## Holst Architecture for 1400 NE Multnomah Type III Design Review, LU 16-137500 DZ

LUR 3 Submitted August 26, 2016

## Overview of LUR 3 Design Changes

# Hassalo Drive Diagram

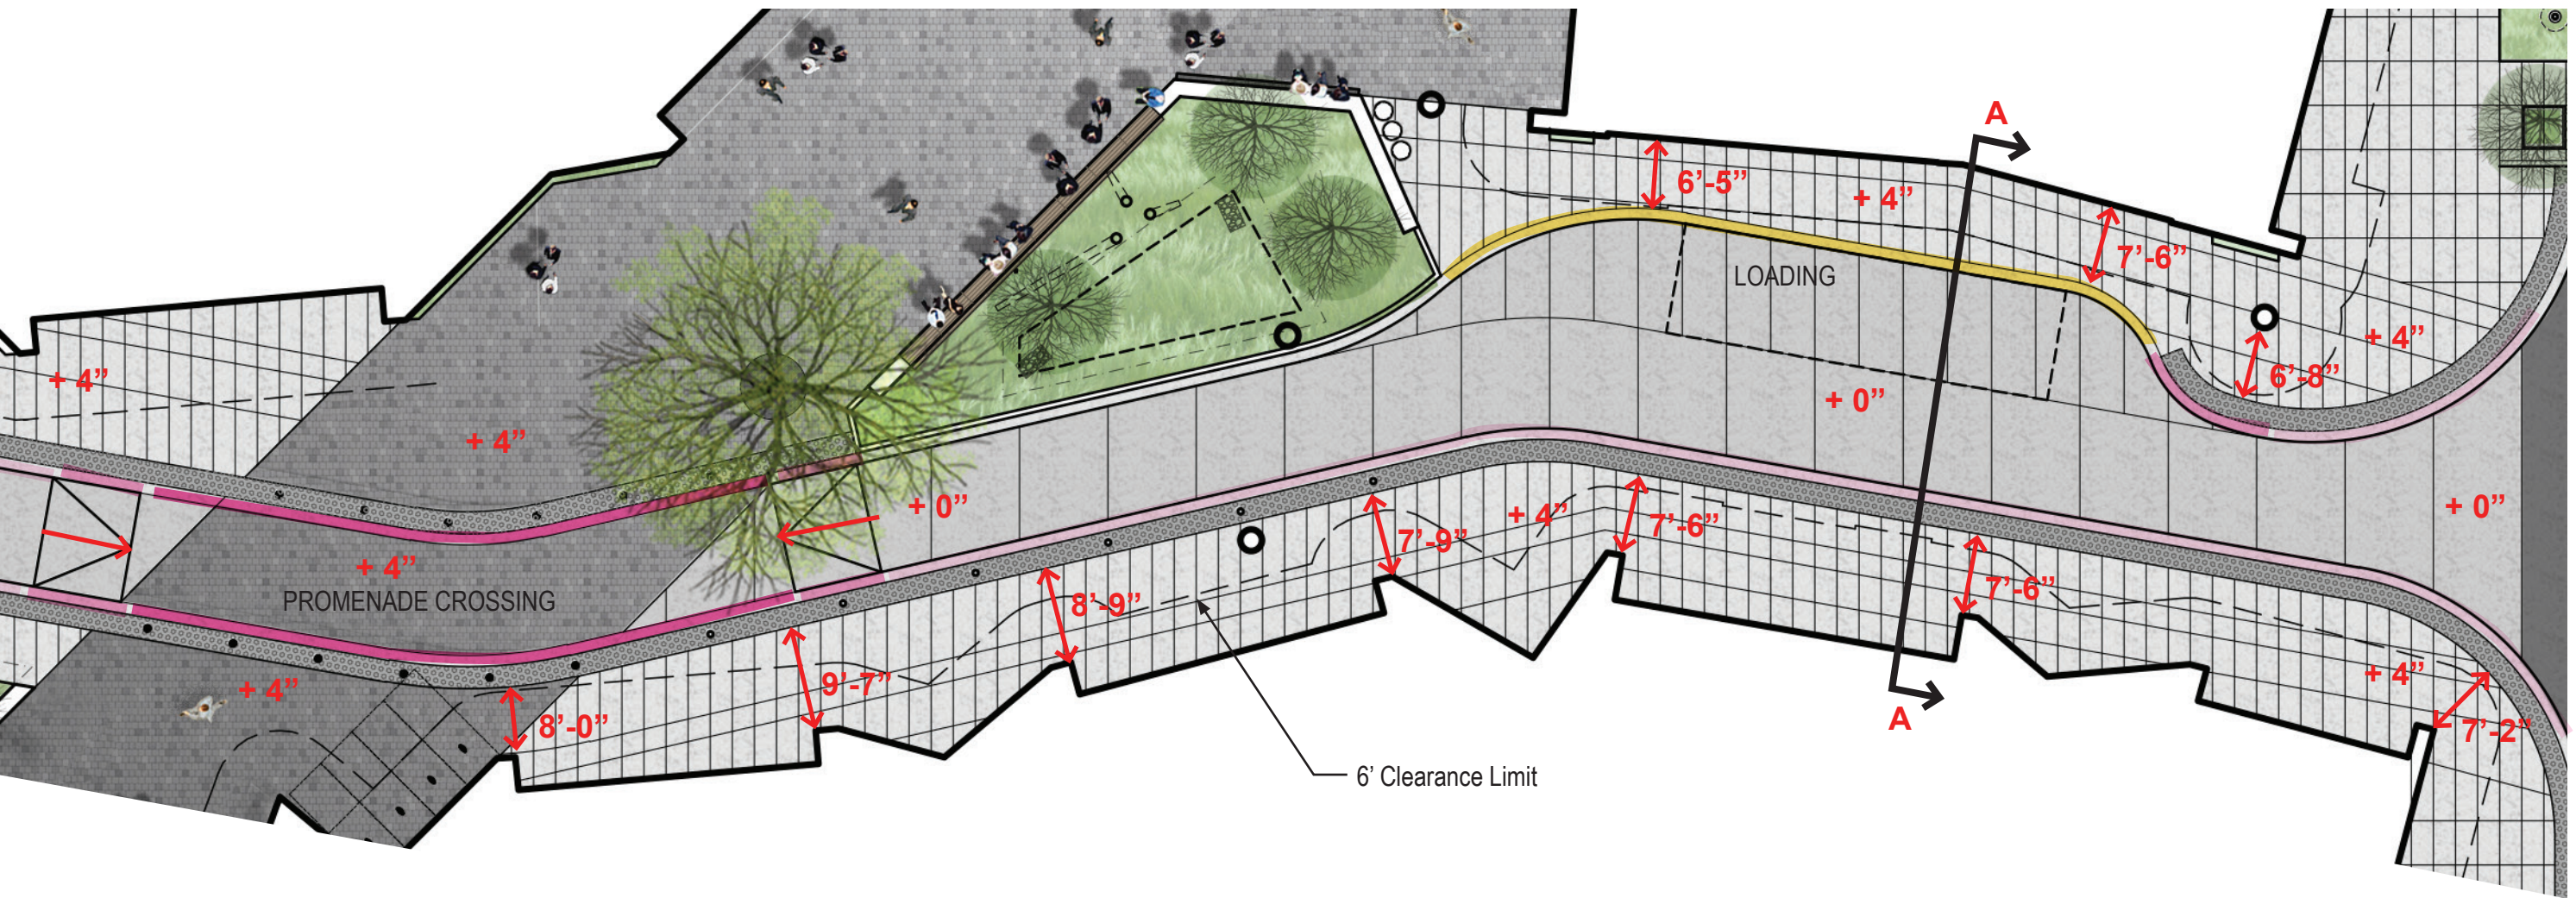
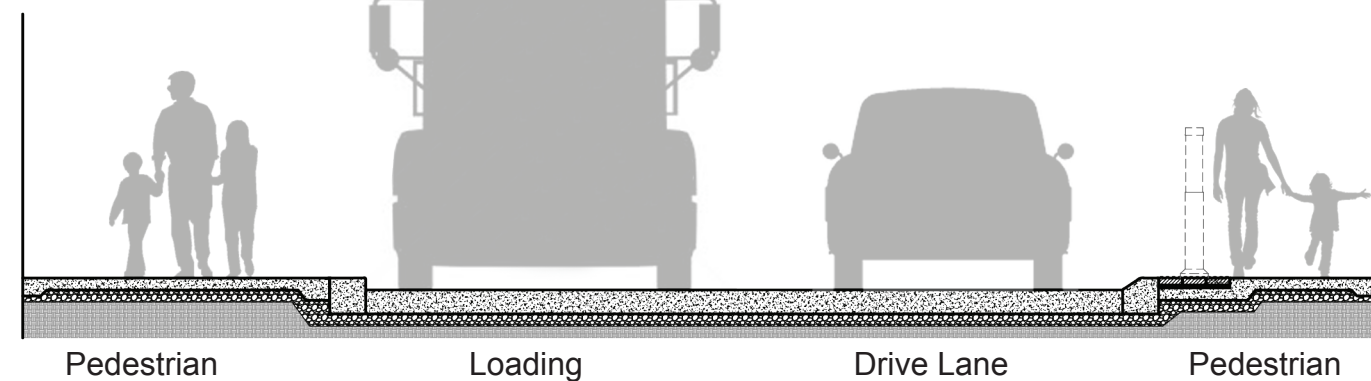
1. Sidewalks widened to 6 feet minimum clear walking zone on Hassalo and 15th Drive.
2. Reduced street parking on 15th Drive to make room for landscape and seating areas and create a more desirable pedestrian experience along the street frontage.

## Weathered Steel Example - Fort McMurray Airport

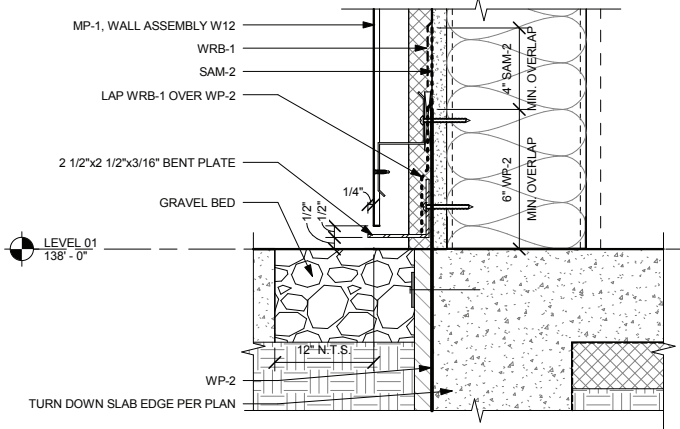
**EXTERIOR:** Confirmed no reports of staining caused by the exterior unfinished pre weathered panels [after 2 years]. They were well seasoned in accordance with the proprietary weathering procedures obtained through the team at Dissimilar Materials [DMD]. Generally this includes removal of mill scale, red oxide treatment, and acid treatments to initiate the oxide layer. The cycle of hydration and oxidation thickens the protective ferrous layer. Prior to shipping they are finished with power washing. No significant bleeding has occurred due to proper seasoning. “touch up” strategy in place for field cuts and scratches – uses a urethane to match – DMD will can assist with this.

# 15th Drive Elevation Perspective

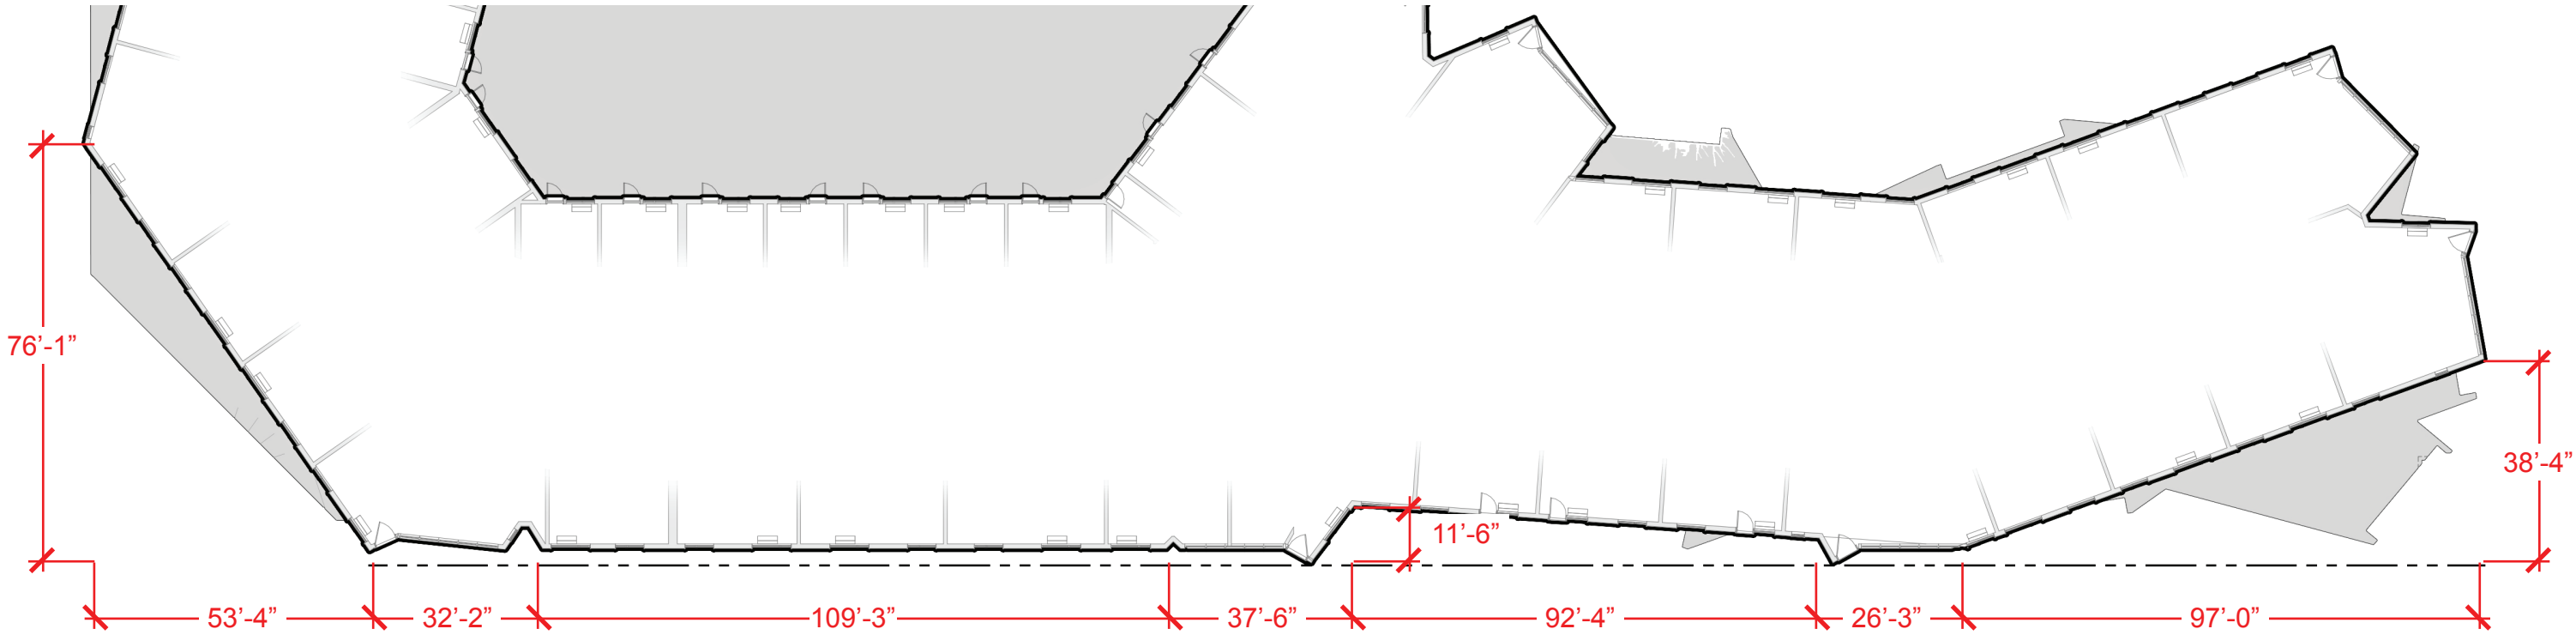
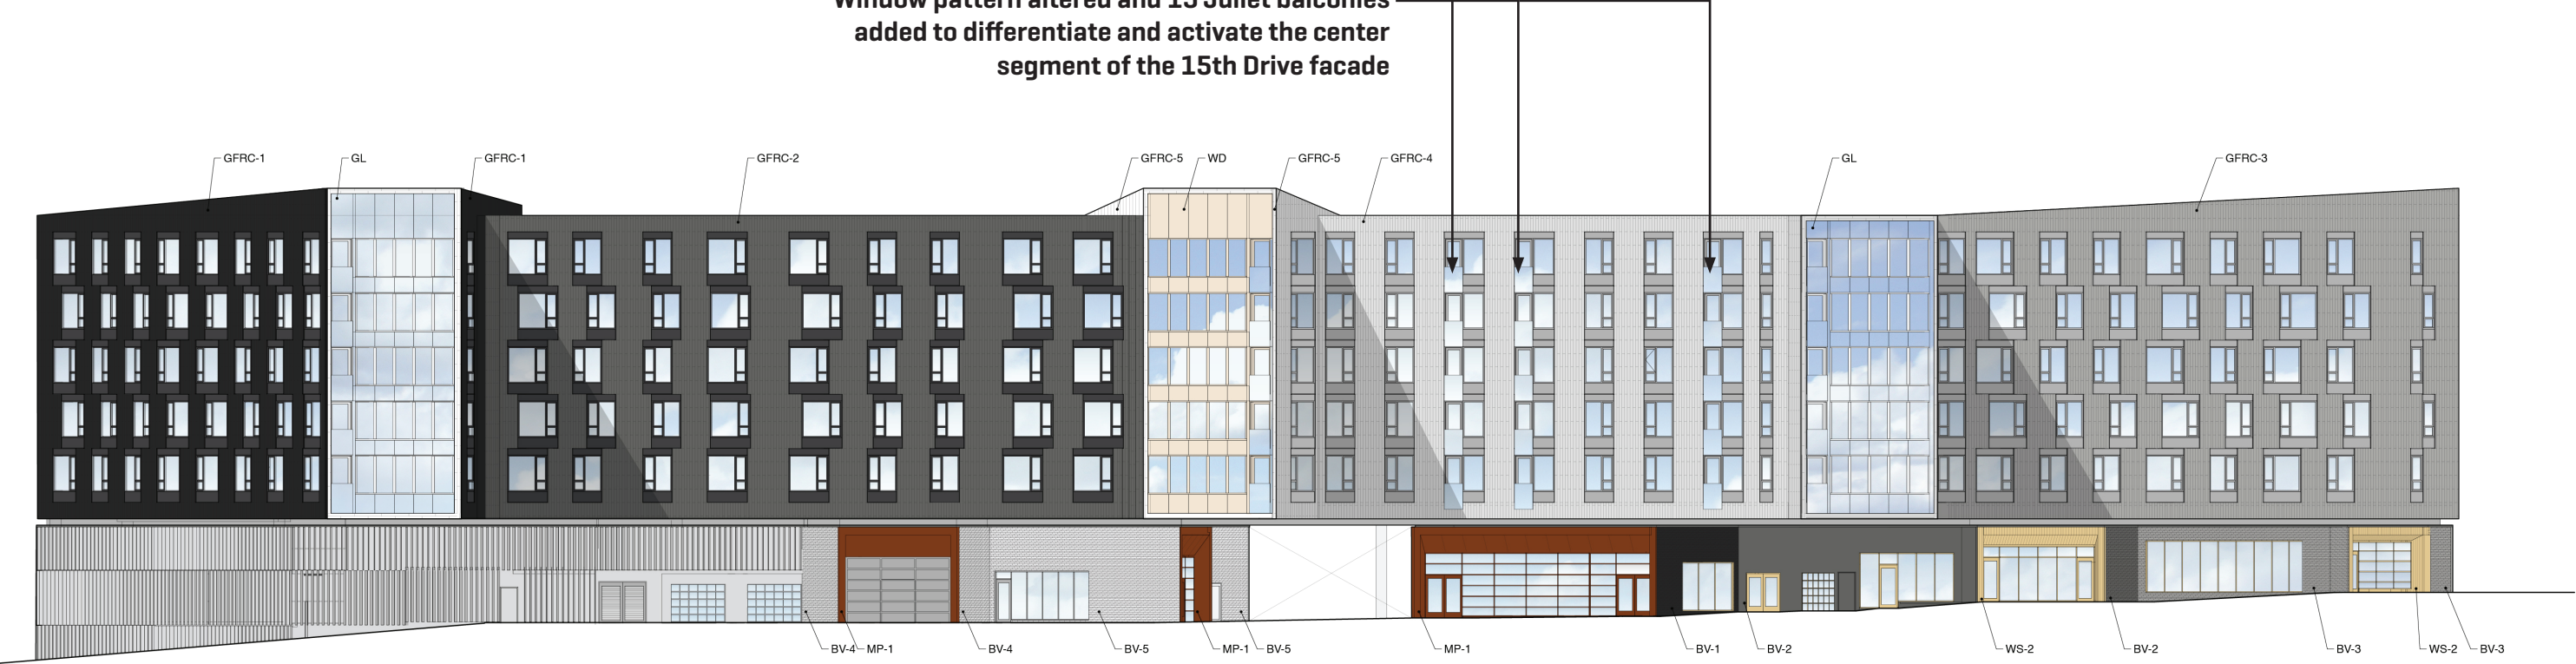
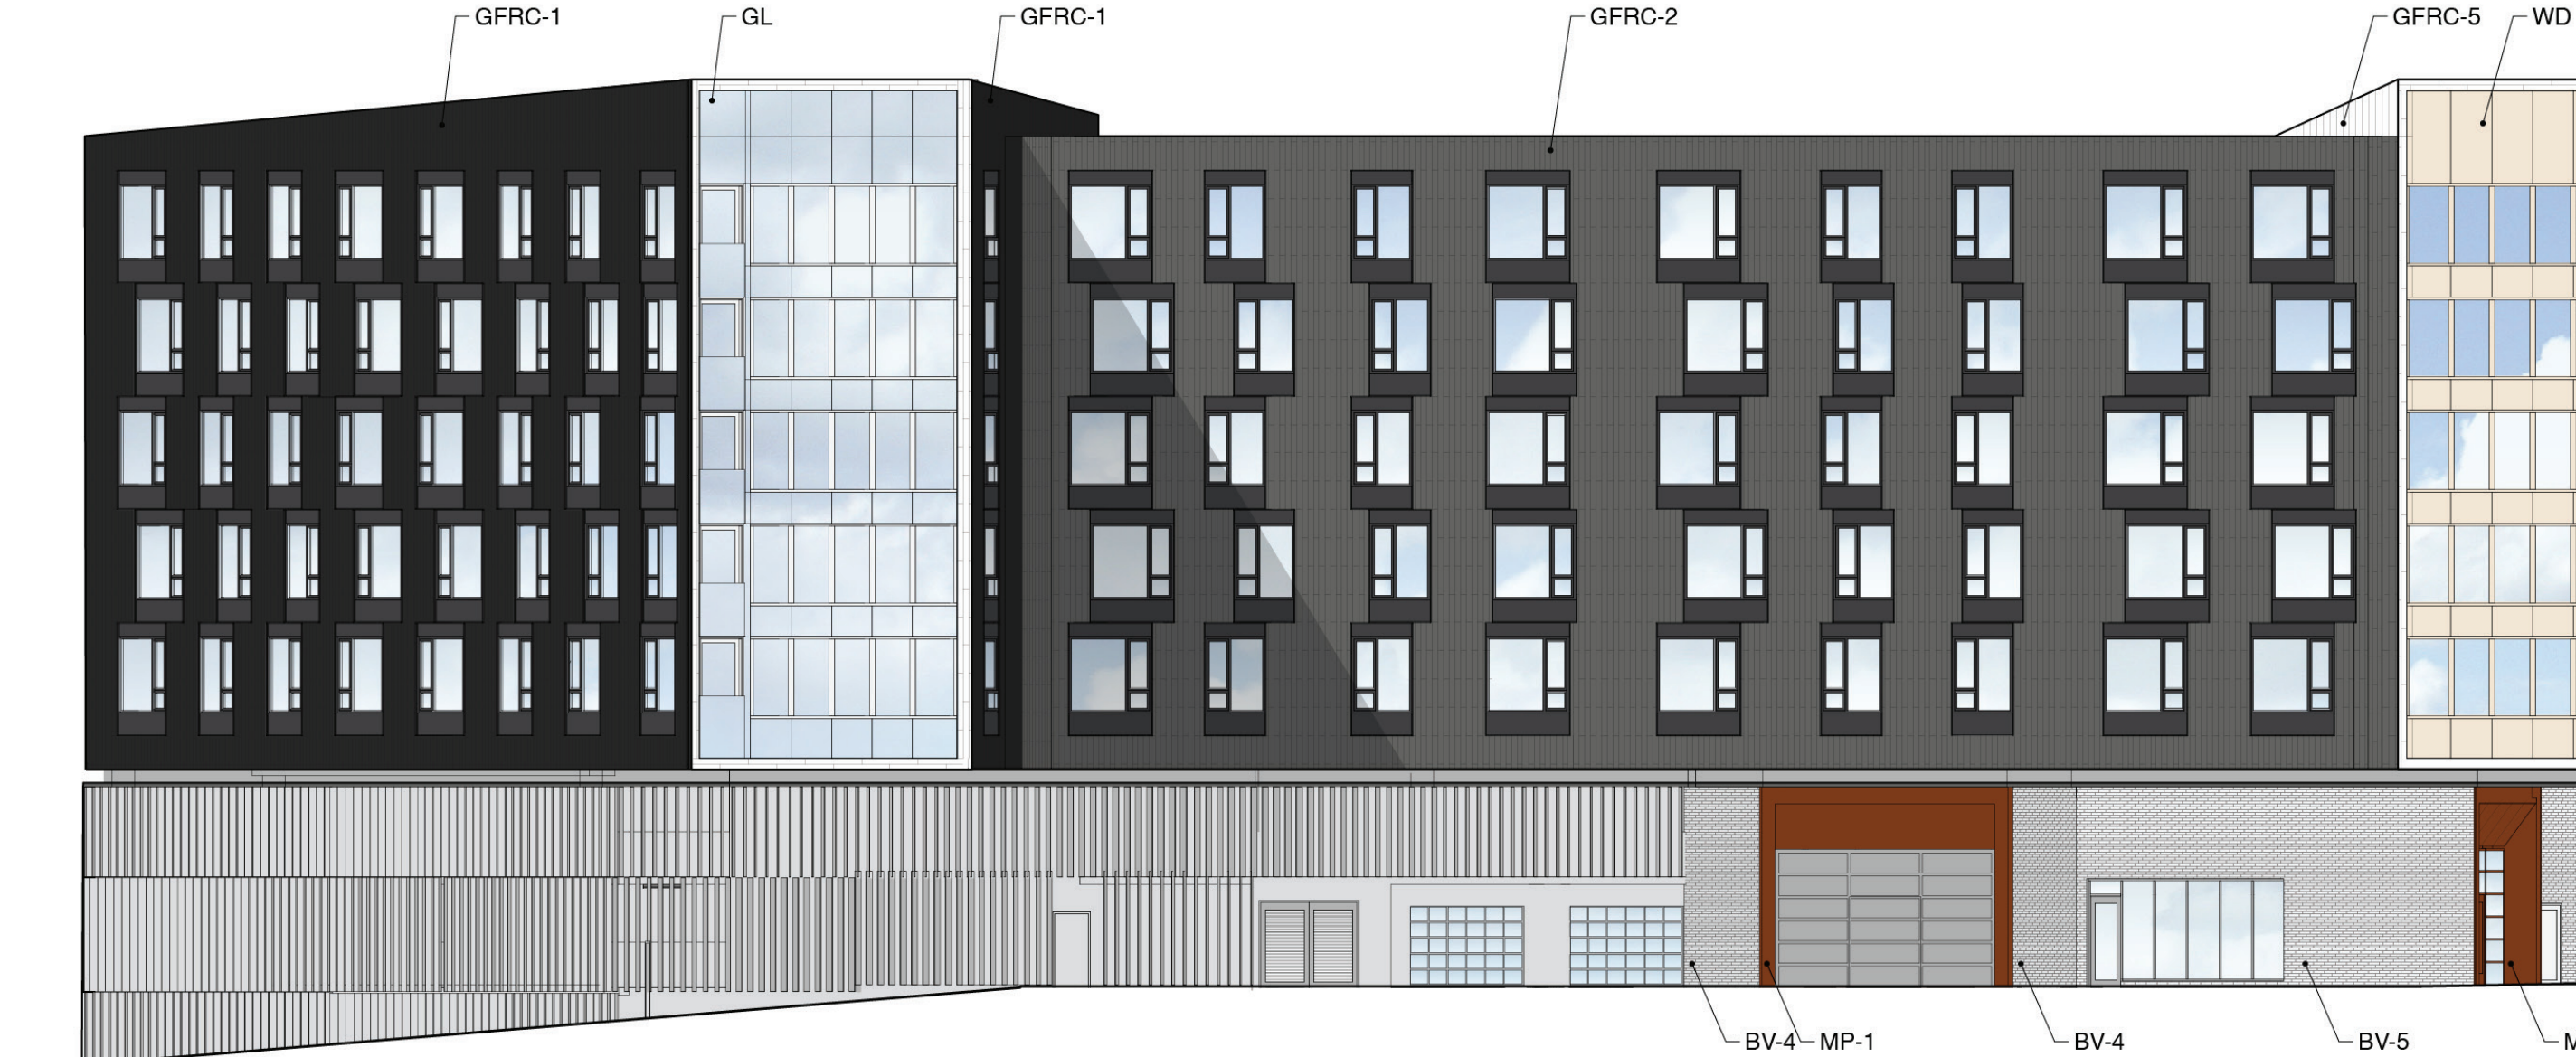
Window pattern altered and 15 Juliet balconies added to differentiate and activate the center segment of the 15th Drive facade
